# UNITED STATES PATENT AND TRADEMARK OFFICE

APPLICATION NO.	FILING DATE	FIRST NAMED INVENTOR	ATTORNEY DOCKET NO.	CONFIRMATION NO.
10/580,826	01/03/2007	Yoshihisa Doi	65341.00007	8305
32294 7590 11/25/2008 SQUIRE, SANDERS & DEMPSEY L.L.P. 8000 TOWERS CRESCENT DRIVE 14TH FLOOR VIENNA, VA 22182-6212				
EXAMINER				
JENNINGS, STEPHANIE M				
ART UNIT		PAPER NUMBER		
4135				
MAIL DATE		DELIVERY MODE		
11/25/2008		PAPER

## Office Action Summary

## **DETAILED ACTION**

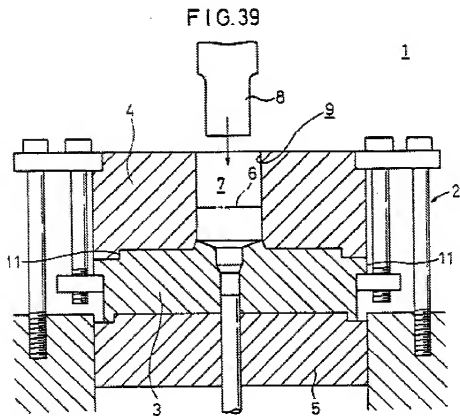
Limitations from claim 5, a forging method as defined in claim 1, wherein the formed product is cup-shaped (8, figure 39 above) (page 1, paragraph 11 and page 2, paragraph 20).

Limitations from claim 6, a forging method as defined in claim 1, wherein the formed product is shaft-shaped (8, figure 39 above) (page 1, paragraph 11).

Limitations from claim 14, a forging apparatus as defined in claim 7, wherein the formed product is cup-shaped (8, figure 39 above) (page 1, paragraph 11 and page 2, paragraph 20).

Limitations from claim 15, a forging apparatus as defined in claim 7, wherein the formed product is shaft-shaped (8, figure 39 above) (page 1, paragraph 11).

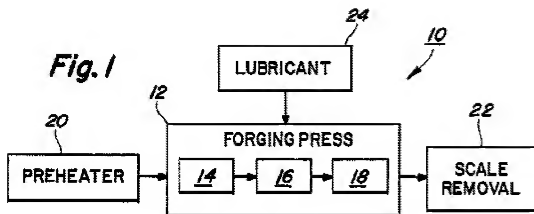
Limitations from claim 4, A forging method as defined in claim 1, wherein the lubricant (24, figure 1 above) before a forging procedure (12) is a water-dispersive lubricant containing a solid lubricant agent, a lubricative and dispersive adherent agent and a wetting and vaporizing accelerating agent, and the lubricant (24) during the forging procedure is a solid lubricant agent (column 3, lines 53-column 4, line 5 and column 4, lines 20-31).

Limitations from claim 13, A forging apparatus as defined in claim 7, wherein the lubricant (24) before a forging procedure (12) is a water-dispersive lubricant containing a solid lubricant agent, a lubricative and dispersive adherent agent, and a wetting and vaporizing accelerating agent, and the lubricant (24) during the forging procedure is a solid lubricant agent ((column 3, lines 53-column 4, line 5 and column 4, lines 20-31).
